Re: PA22-024- Marysville 44th PRD – Technical Review 1
 7315 / 7417 44th St NE – APN(s) 30053500303700 / 30053500303600

After preliminary review of the above referenced proposal, the Planning Division has the following comment(s):

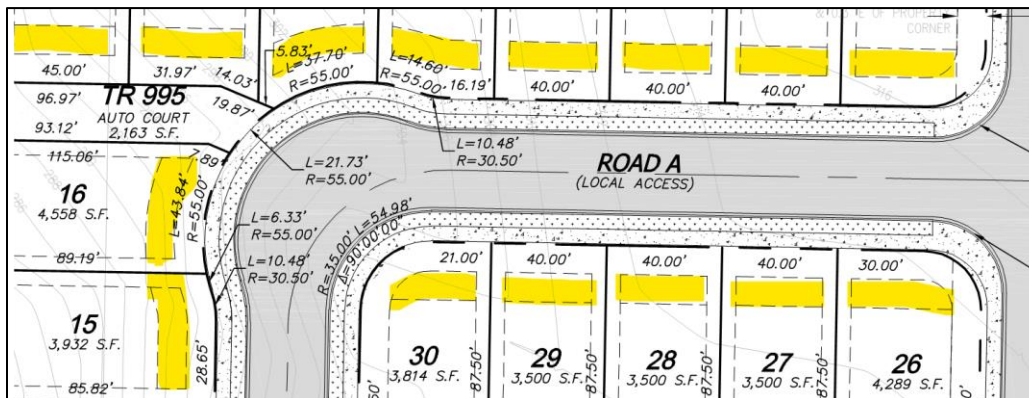
- 4.2. Provide call out details for said walls and include wall symbols in legend.
5. Please provide clarification as to what the roughly 300 sq. ft. highlights areas are below:
